Revised Pedal Cover Panel and Heater Air Duct

M-872-001

(October 2008)

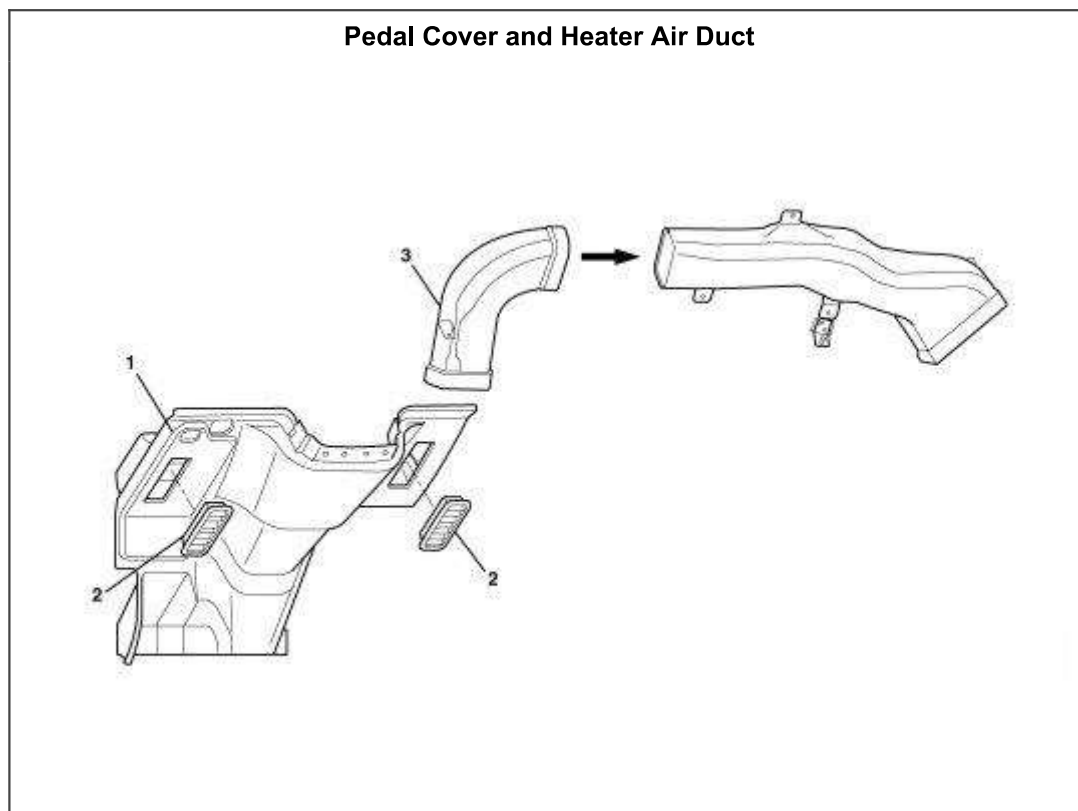
Effective September 19, 2008, a revised pedal cover panel (part number 82166134 for manual transmissions, or 82166137 for automatic transmissions) and heater air duct (part number 82139961) were implemented into production on CXU, CXP, CHU, GU, CTP and TD model chassis. These two components have been revised to provide improved air flow to the driver-side foot area, and are also available through the MACK Parts System for installation on chassis manufactured prior to the above implementation date should complaints of insufficient heated air flow to the driver-side foot area be encountered.

Key	Qty.	Part number	Description	Replaces
1	1	82166134	Panel, pedal cover, vehicles with

manual transmission	
	1	82166137	Panel, pedal cover, vehicles with automatic transmission	
2	2	217RD45M*	Louver, air outlet	
3	1	82139961	Air duct

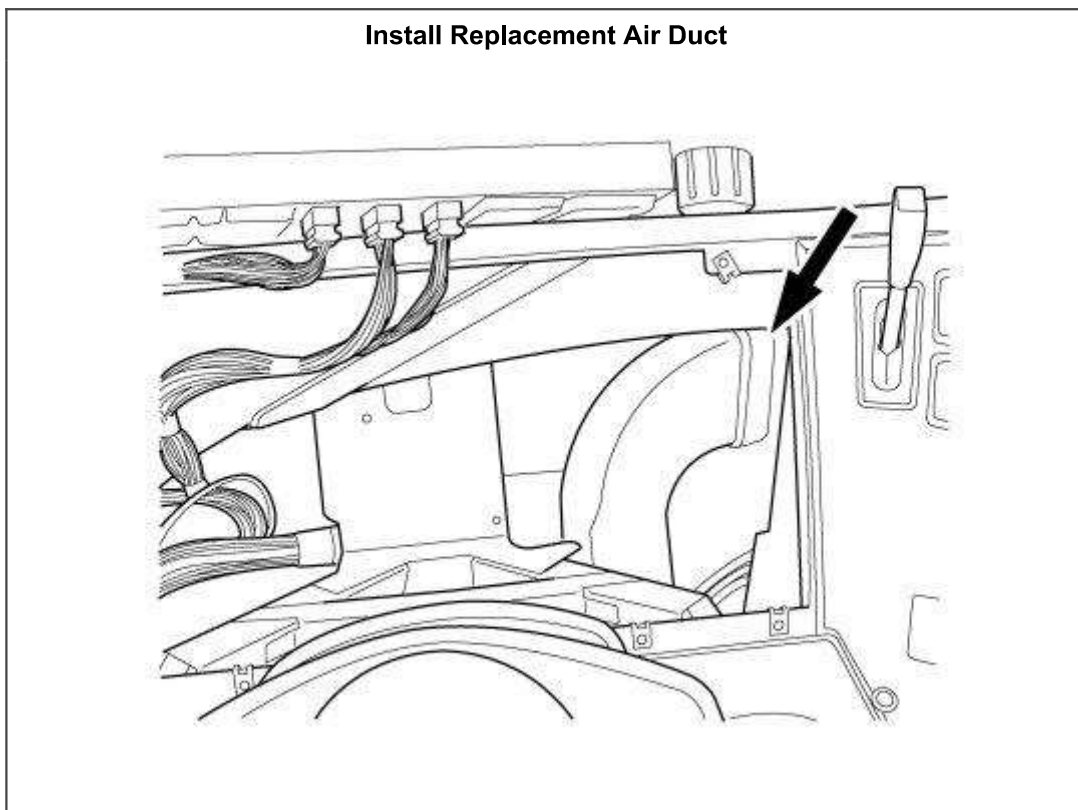
9. Slide the replacement air duct (part number 82139961) into place, making sure the upper end of the duct engages the main heater duct behind the instrument panel.

Note: It may be necessary to reposition the main cab harness bundle and air lines in such a way so as to allow sufficient clearance for the replacement air duct. If this is not done, the harness and air lines will push against the end of the air duct, causing it to disengage from the pedal cover plenum, causing air leaks and heat loss.

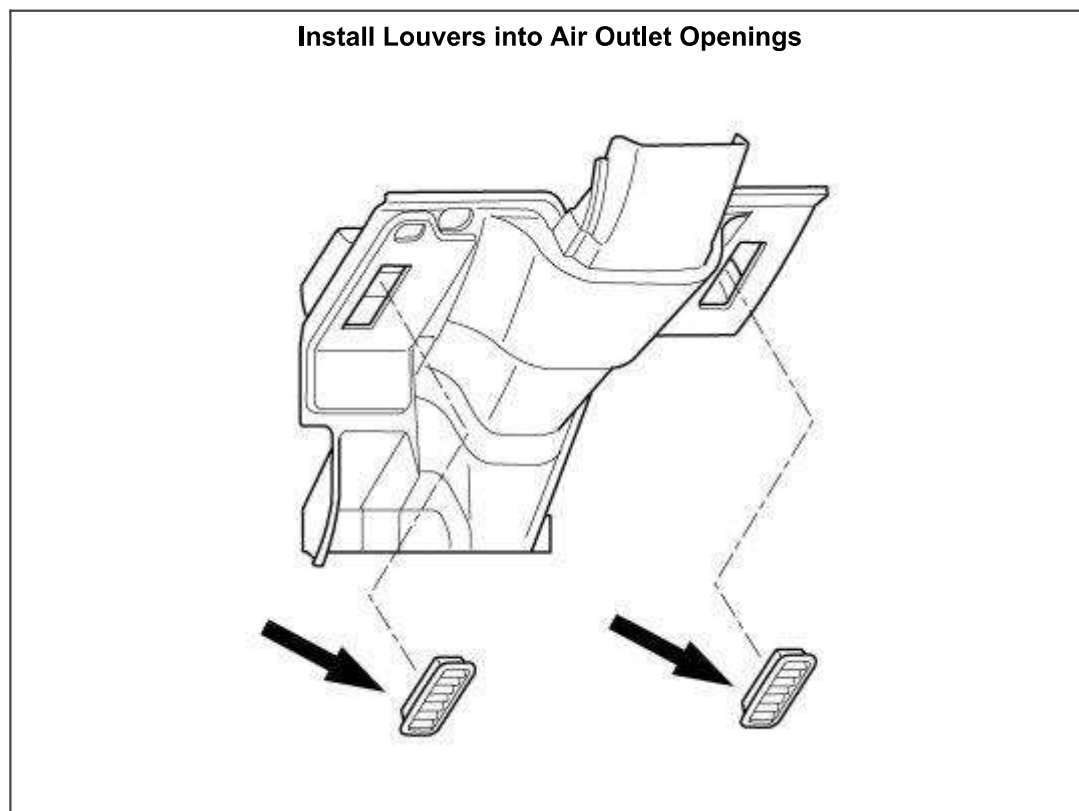
12. Snap the air outlet louvers (part number 271RD45M) into the air outlet openings in the pedal cover.

Note: The part number 271RD45M louvers are required only for chassis manufactured prior to November 19, 2007. For chassis manufactured after this date, it is only necessary to transfer the louvers from the existing pedal cover to the replacement cover.
